SHEET NAME: PLAN
PROJECT NAME: SWANTON
PROJECT NUMBER: STP ST MHTB(1)

FILE NAME: z:f024p11.dgn
PROJECT LEADER: M. K. CHEVALIER
DESIGNED BY: B. ERNST
PLOT DATE: 2/13/2008
DRAWN BY: R. ROSS
CHECKED BY: M. K. CHEVALIER
SHEET 6 OF 63

PLAN

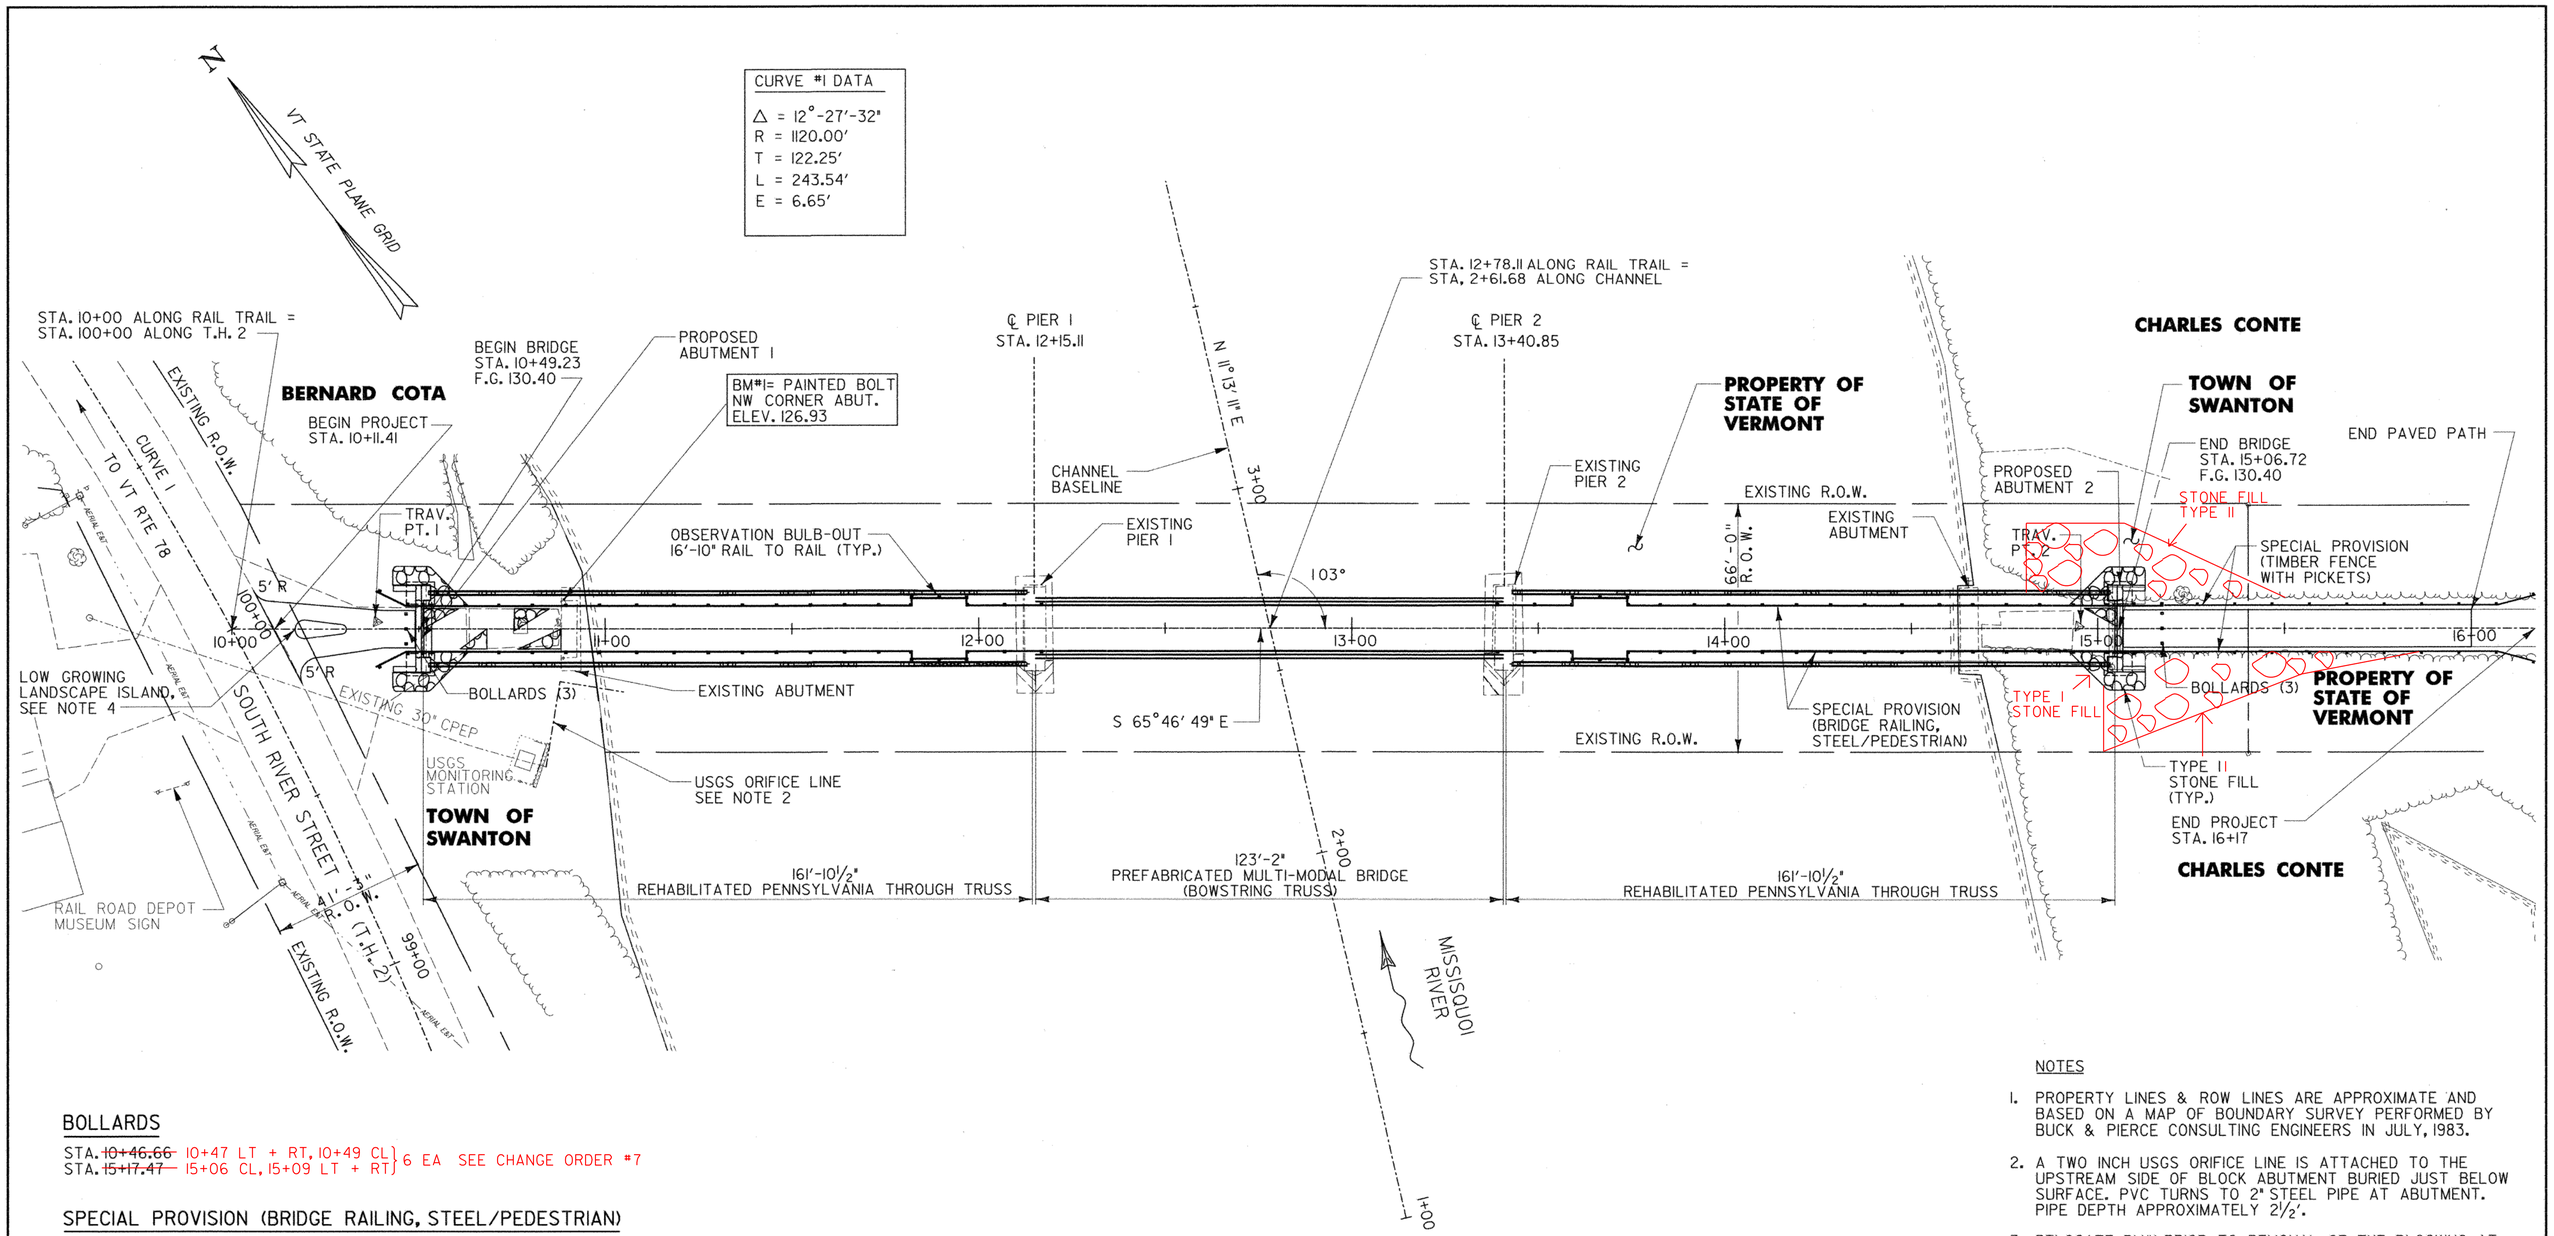
STA. ~~10+46.66~~ 10+47 LT + RT, 10+49 CL } 6 EA SEE CHANGE ORDER #7
STA. ~~15+17.47~~ 15+06 CL, 15+09 LT + RT }

STA. 10+38.08 TO ~~15+17.74~~ LT. 15+20 LT }
STA. 10+38.08 TO ~~15+17.74~~ RT. 15+20 RT } CHANGED TO GALVANIZED RAIL SEE COSA #1

STA. ~~10+16.91~~ TO STA. ~~10+30.66~~
10+19 TO 10+32

15+10.5 STA. ~~15+17.74~~ TO STA. 16+17.00 LT.
STA. ~~15+17.74~~ TO STA. 16+17.00 RT.
15+10.5
